ADDENDUM #6

PROJECT : CODESTACK ACADEMY

REF. # : ARCH PROJ. No. 2023-04

DATE : 21 March 2025

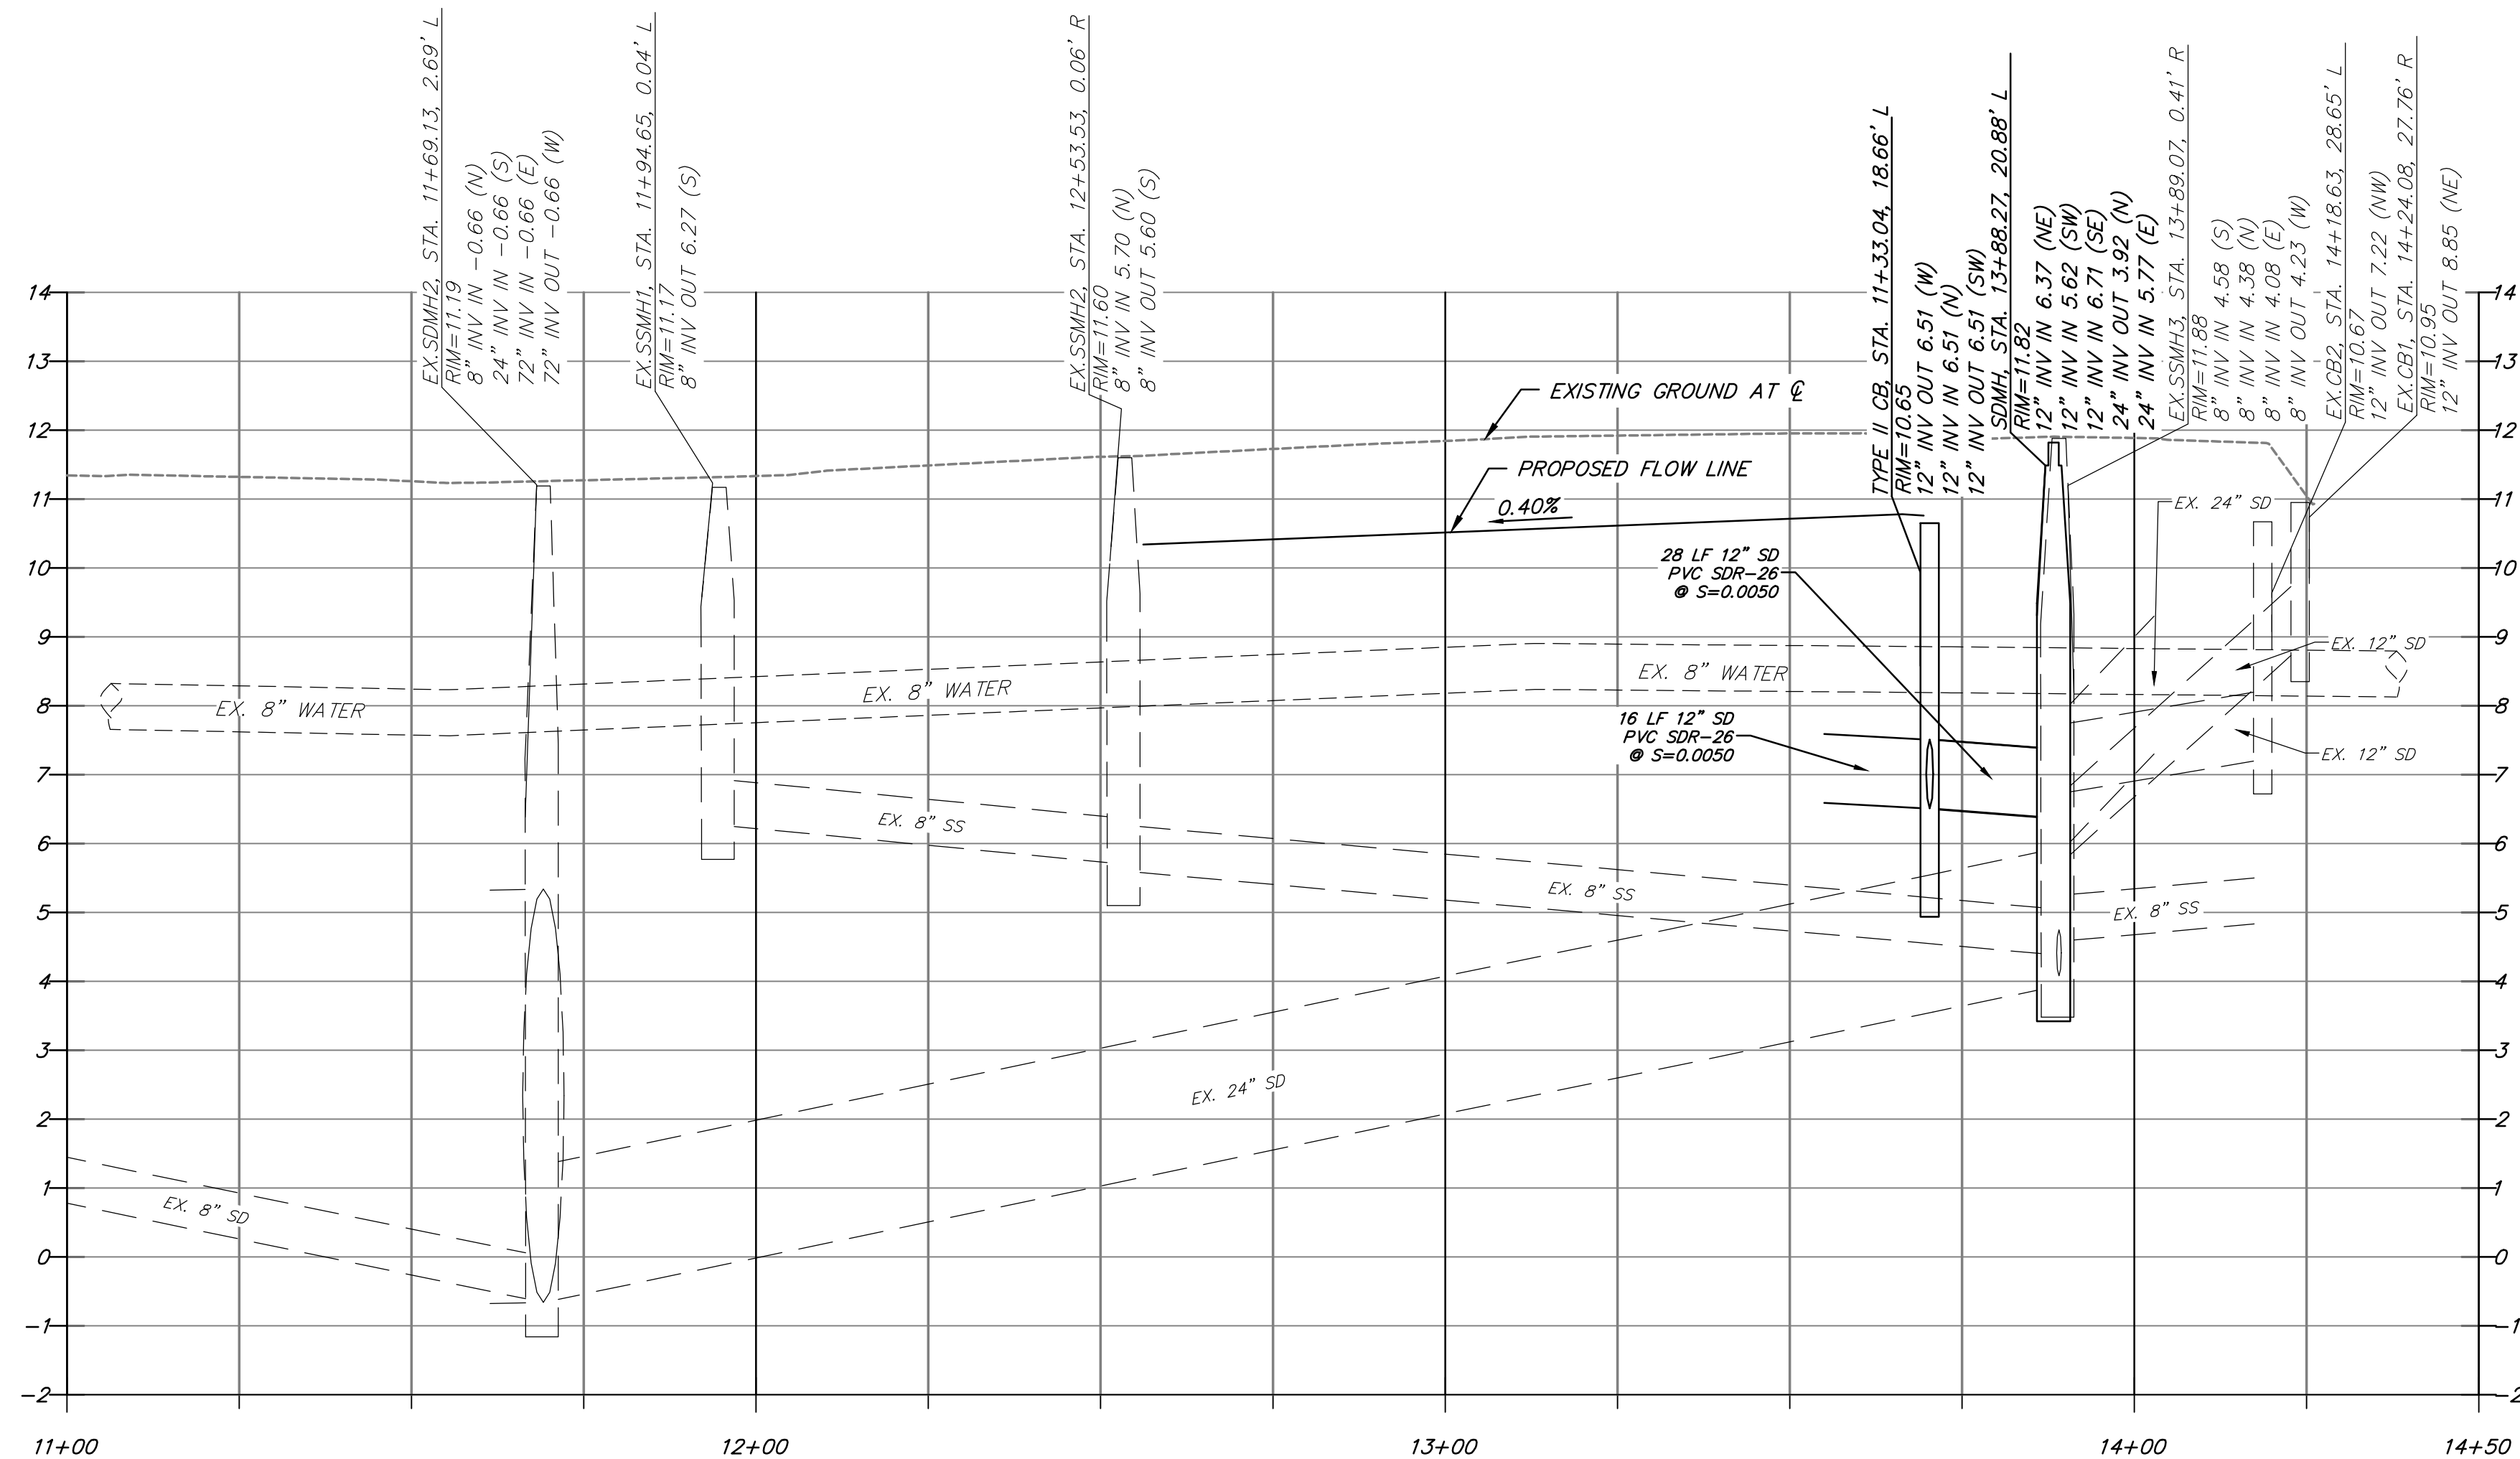
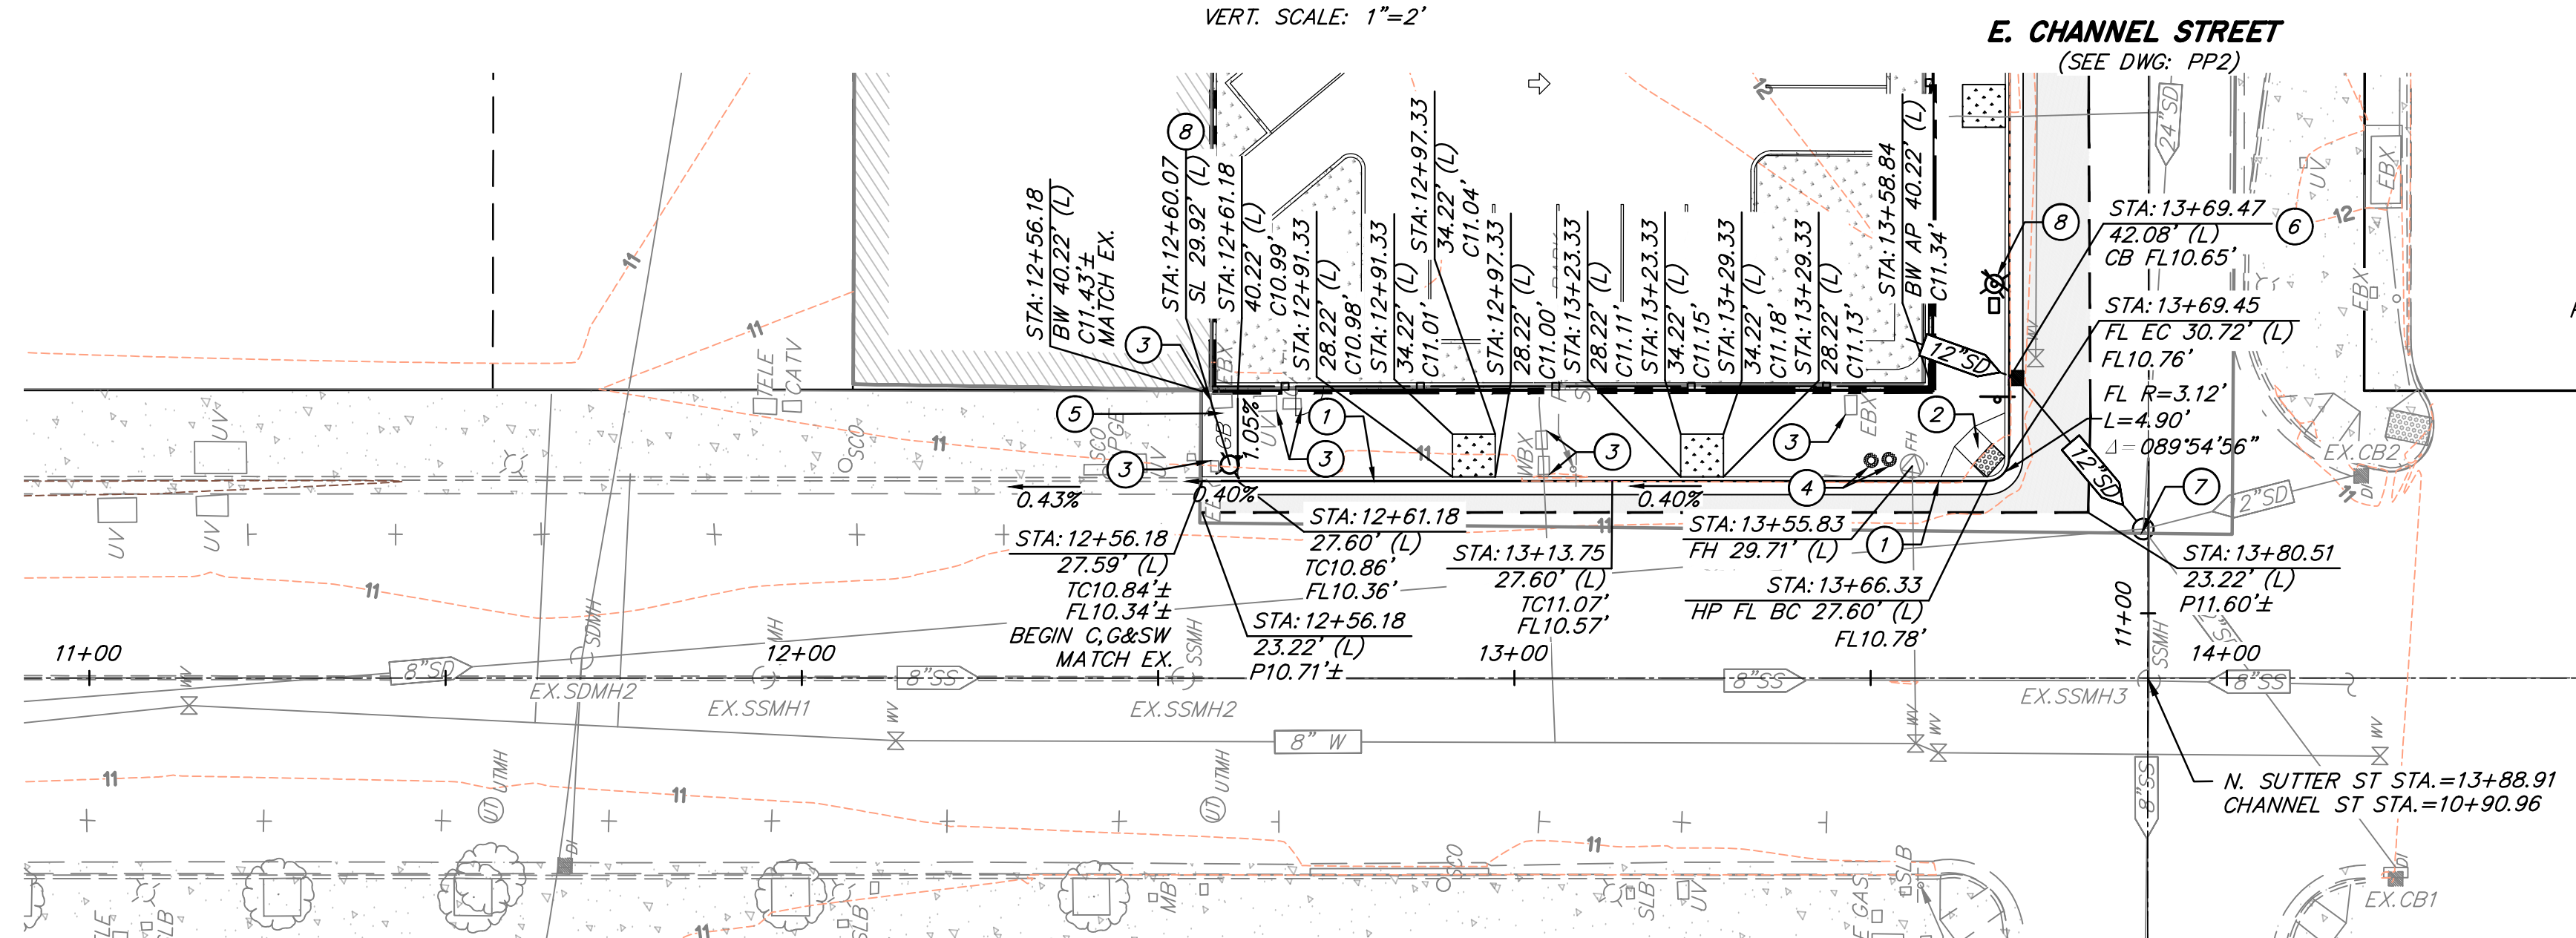
MVE Response: The catch basin on E Channel Street now connects to the new manhole in the intersection of E Channel Street and N Sutter Street.

- b. Added note 8 regarding streetlights.

16 ROOF TO ELEVATOR WALL DETAIL

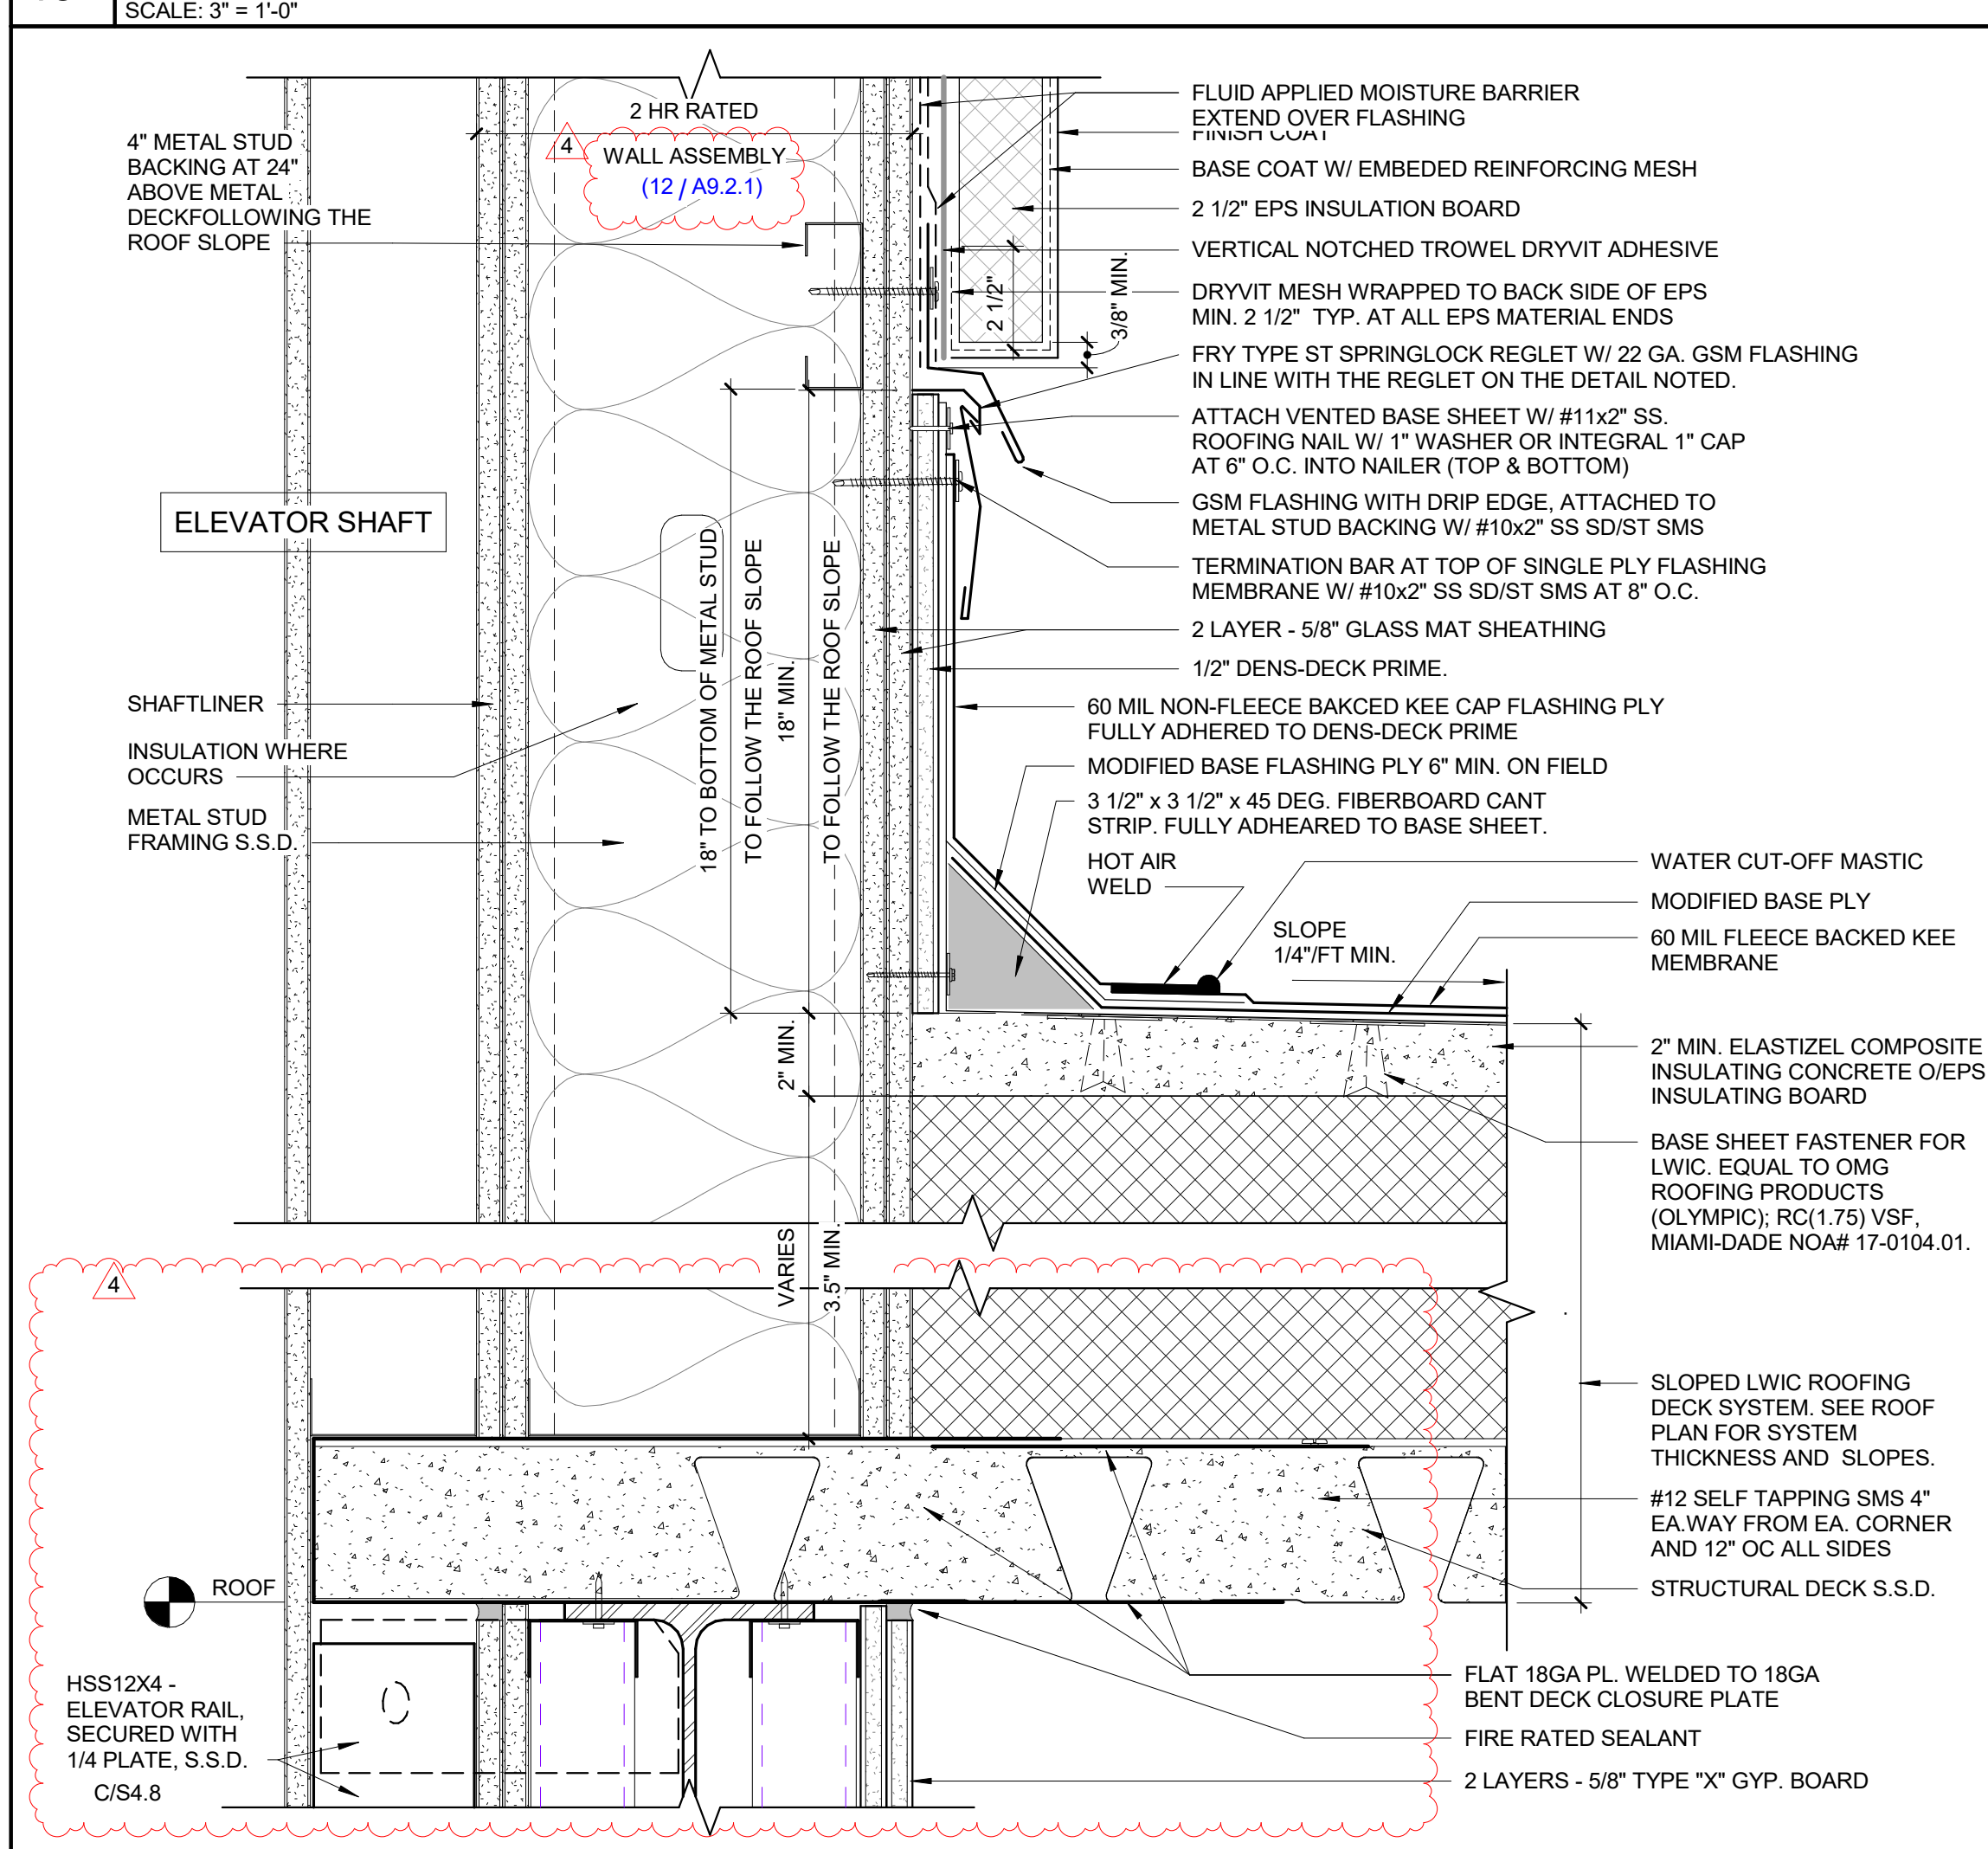
QUESTION (03.11.25): 16/A9.3.2 shows a 3x3 support angle attaching to studs thru two layers of gyp. What is this support angle supporting? It does not match the typical details for supporting the metal deck, nor could it be sequenced in order to construct this way if that were the case. Please confirm what the intent of this 3x3 angle is and also please confirm if this angle is sized or gauge material?

RESPONSE: Detail has been revised to match structural connections. 3x3 angle in question removed. See revised sheet A9.3.2R (attached), with revised detail 16. Detail 16 has also been revised to reference detail 12/A9.2.1 for rated wall assembly.
